**AGENDA  
CITY OF LAKE WORTH BEACH  
HISTORIC RESOURCES PRESERVATION BOARD REGULAR MEETING  
CITY HALL COMMISSION CHAMBER  
WEDNESDAY, MAY 13, 2020 -- 6:00 PM**

A. Consideration of a Certificate of Appropriateness (COA) for the new construction of a ± 2,245 square foot two-family structure at **711 North L Street**; 38-43-44-21-15-218-0140. The subject property is located in the Single-Family and Two-Family Residential (SF-TF 14) Zoning District and the Northeast Lucerne Local Historic District.

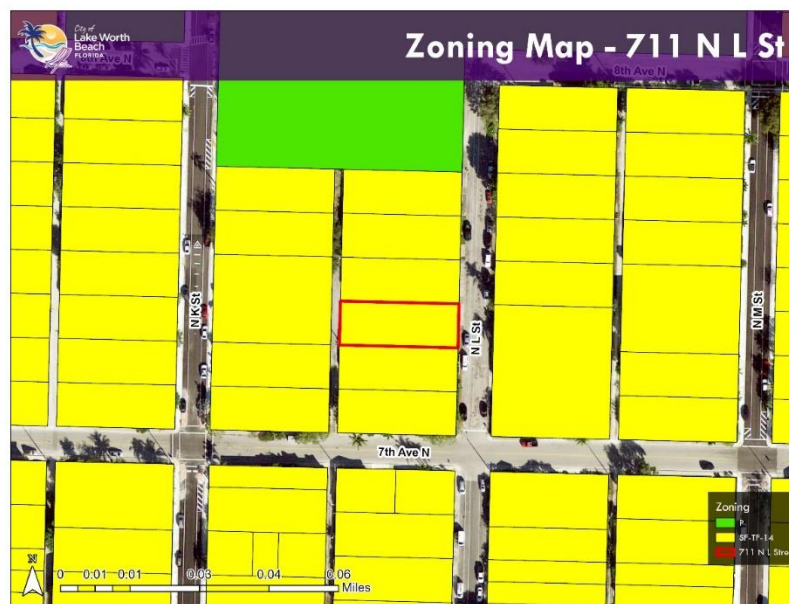
The Front Yard Impermeable Surface Total for the subject property is 250 square feet. The proposed site plan indicates that 255 square feet of the front yard will be impermeable. Staff has added a condition of approval so that the front yard would comply with the zoning requirement. This condition requires that a variety of pervious materials and driveway designs may be utilized to reduce the impermeable area and achieve compliance. The minimum dimensions for parallel parking spaces are 9'x22'. The proposed site plan indicates an 8'x20' parallel parking space is proposed. Staff has added a condition of approval that the rear parking space complies with the zoning requirement. There is sufficient space in the rear yard to accommodate the minimum parking dimensions. If the impermeable surface total for the lot becomes an

issue, since the additional lot coverage was not accounted for, the Applicant may utilize pervious materials to reduce the impermeable area.

- 10) A walkway connecting the front door with sidewalk shall be added. Adjustments to the material or design of the front yard may be required to ensure front yard impermeable surface totals are not exceeded.

- 11) The site plan shall be revised to comply with the front yard impermeable maximum.
- 12) The rear parallel parking space shall be revised to meet the minimum required dimensions.

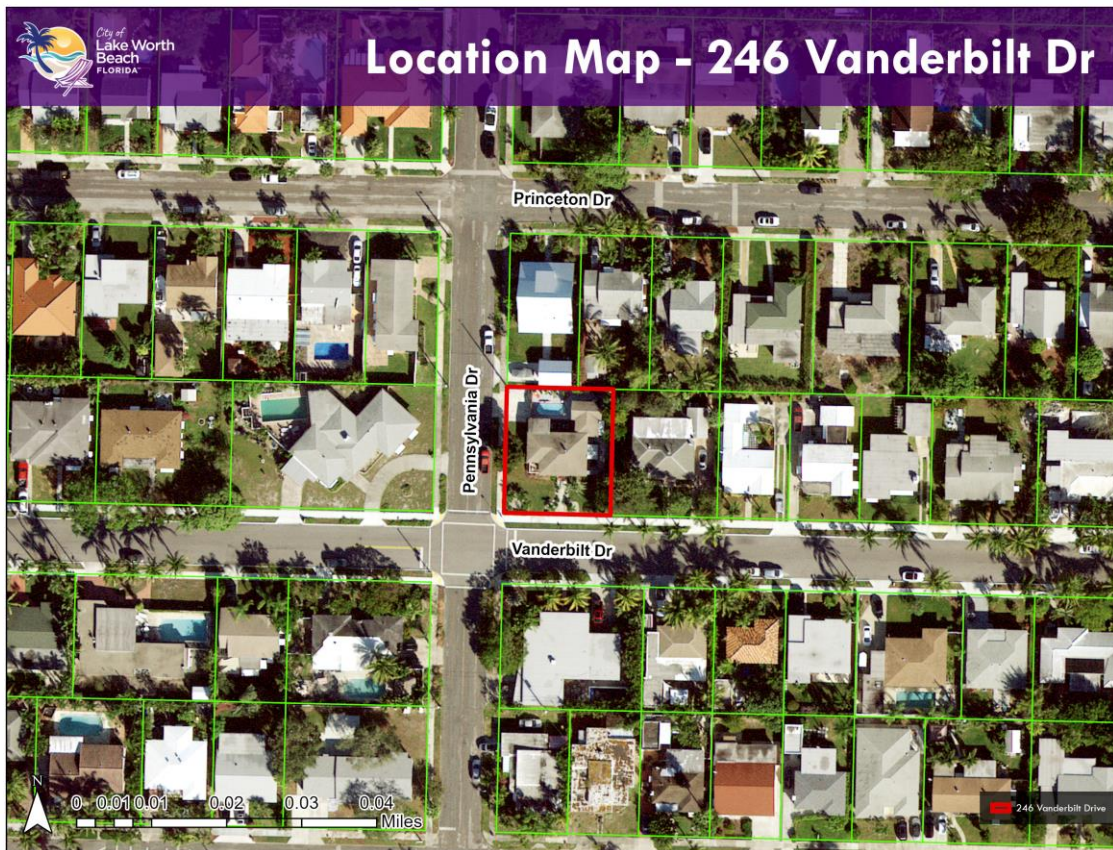
By utilizing semi-pervious materials, the total area calculation of impermeable surface for the new driveway is reduced to 295 square feet. The front yard impermeable surface total for the subject property is 553 square feet. The proposed site plan indicates that 410 square feet of the front yard will be impermeable, which is in compliance with the zoning requirement.

the property survey, the 20'x29.5' driveway will overlap with the southeast corner of the front façade of the residence. The length of the proposed driveway also extends to the front setback of the building, which is typical for commercial and multi-family structures within the historic districts, but atypical for single-family residences. The width and length of the proposed driveway are generally greater than what is necessary to accommodate two off-street parking spaces. Staff has added conditions of approval to reduce the size of the driveway from 20'x29.5' to 18'x18'. An 18'x18' driveway, set one foot (1'-0") from the east property line will eliminate the overlap of the driveway and the front façade of the structure. Terminating the driveway at eighteen feet (18'-0") in length instead of the proposed twenty-nine and a half feet (29'-6") will also create a lawn or landscape buffer between the driveway and the front façade of the structure, which is more compatible for single-family residences.

**STAFF RECOMMENDATION:** Staff recommends approval with conditions that modify the size and material of the driveway as provided on page 6.
